**POTALA VILLAGE MIXED USE DEVELOPMENT  
FINAL ENVIRONMENTAL IMPACT STATEMENT MITIGATION MEASURES  
AND ZONING CODE REQUIREMENTS  
December 20, 2013**

The City of Kirkland issued the *Potala Village Mixed Use Development Draft Environmental Impact Statement (EIS)* on July 12, 2012, and the Final EIS on November 2, 2012. The Draft EIS and Final EIS may be referenced collectively herein as the “EIS.” The EIS has identified probable, significant impacts that would occur with the future development of the Potala Village Mixed Use project together with a number of potential measures to mitigate those significant impacts.

Drawing Title  
**GROUND LEVEL PLAN (NEW DRIVEWAY)**

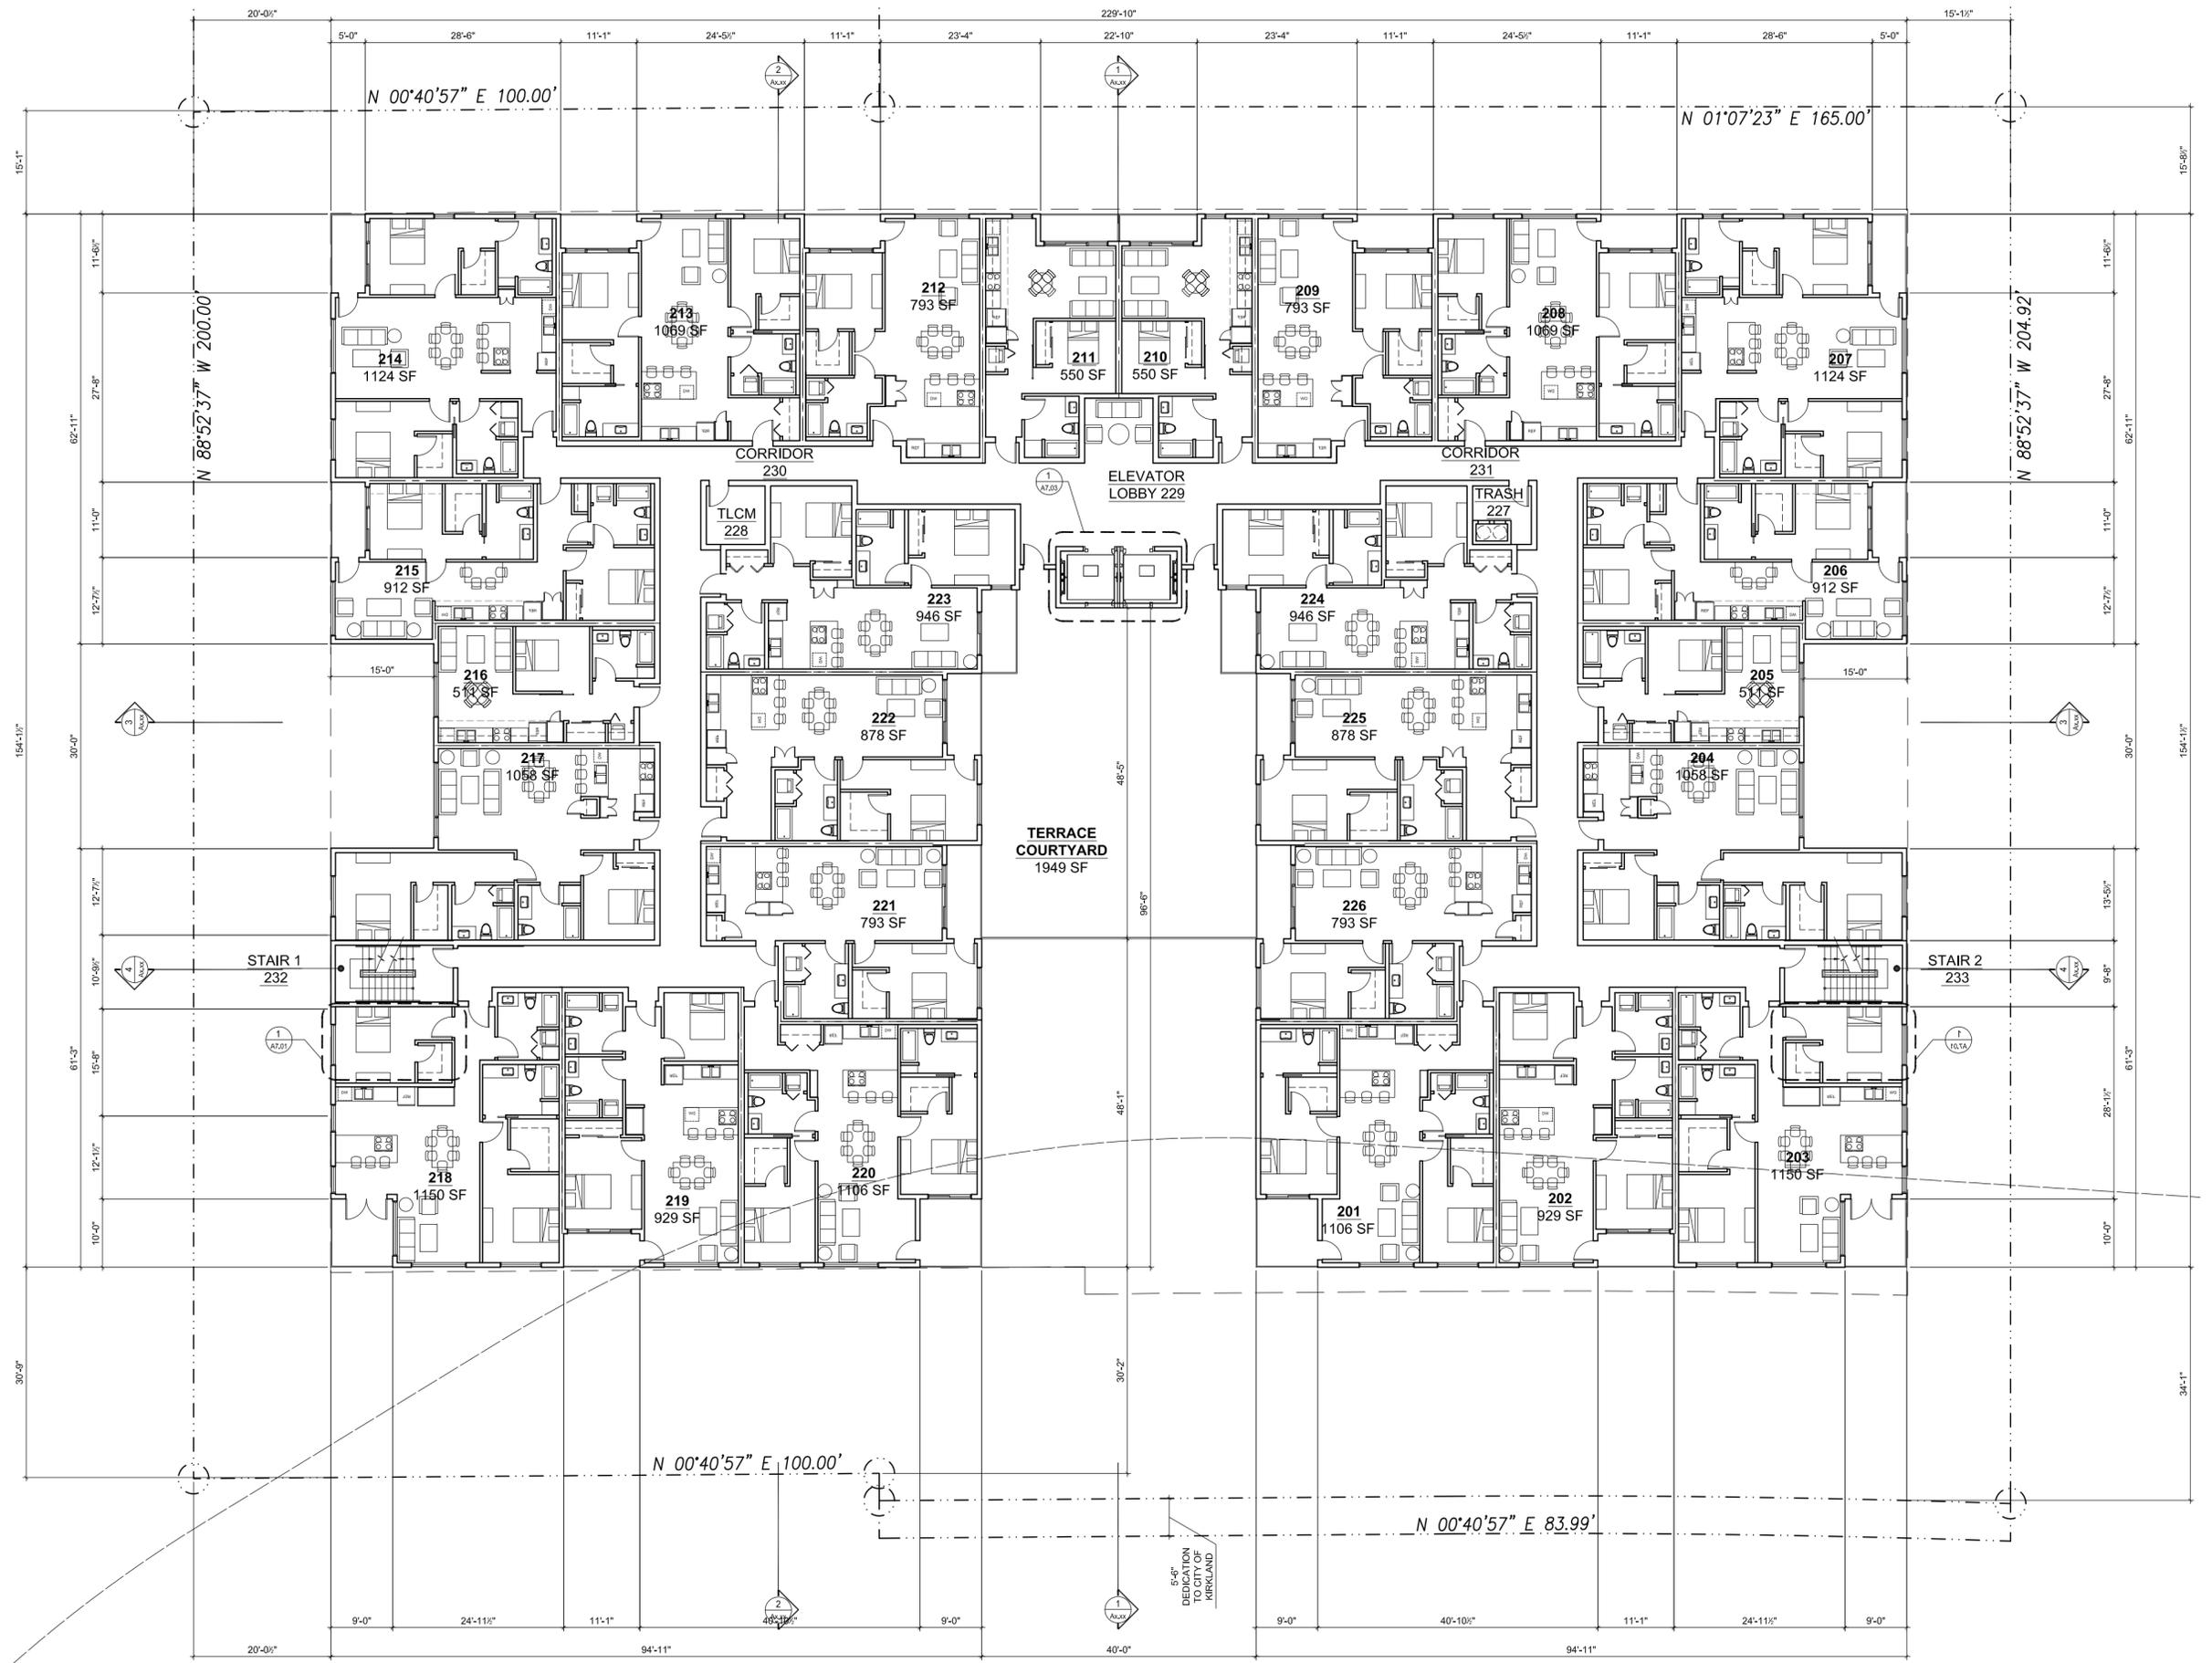
- In a follow-up meeting, per the City's request, the applicant provided a preliminary site plan that located a driveway off of 10<sup>th</sup> Avenue South, close to the site's eastern property line. The proposed driveway met the driveway spacing criteria. Staff reviewed the site plan with the applicant's team and found:

- Subsequently, the applicant presented a site plan meeting the 150 feet driveway spacing requirement from 10<sup>th</sup> Avenue South.
- Through the State Environmental Policy Act (SEPA) and EIS review processes, Public Works staff required safety analyses at the proposed driveway to ensure that it would operate safely.

**A3.02**

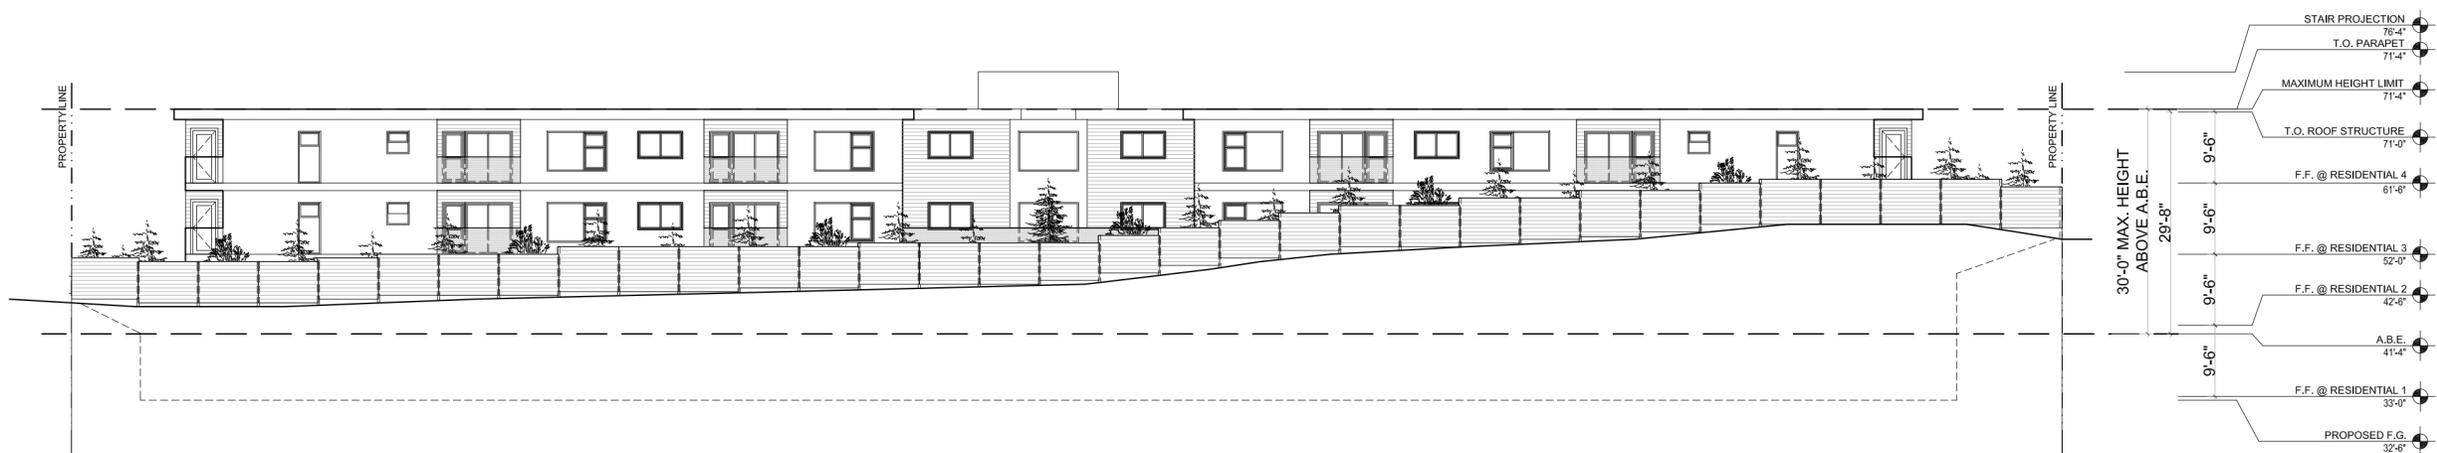
***As required by Section 95.42 Kirkland Zoning Code, required landscape buffers shall provide effective screening for adjacent properties. The proposed site plan needs to be revised to meet the intent of the required landscape buffers. Modifications to the proposed site plan to meet this requirement could include shifting the retaining walls along the east, north and south property lines from the outer edge***

***of the buffer to the inner edge and installing the landscape buffer between the retaining walls and property lines, widening the buffers to provide an adequate area along the retaining walls for a raised platform so that planted vegetation provides screening above the fence line at time of planting, or other measures as approved by the City.***

- The following revisions are proposed to meet the intent of the Kirkland Zoning Code to minimize visual and noise impacts.
- At the east and south property lines, locate a portion of the land-use buffer (at least 1/2 of the required buffer and also at the very least adequate to meet planting requirements, whichever is greater) at or near adjacent grade and sloping towards the interior of the site from the property line at a 2:1 ratio. On north side, locate the buffer in a similar fashion (at or near grade at the property line and sloping at a ratio of 2:1) to the east and south but instead of breaking the buffer into two (2) distinct levels, all of the required buffer will occur in one.

Staff agrees with the above proposal and the Kirkland Zoning Code analysis (see Attachment 1, Drawings 1/8, 5/8, 6/8, 7/8 and 8/8 and Attachment 2, Drawings A3.01 through A3.04 for a graphic

representation). The proposed buffers will provide effective screening for adjacent properties and meet the intent of Section 95.42 of the Kirkland Zoning Code.
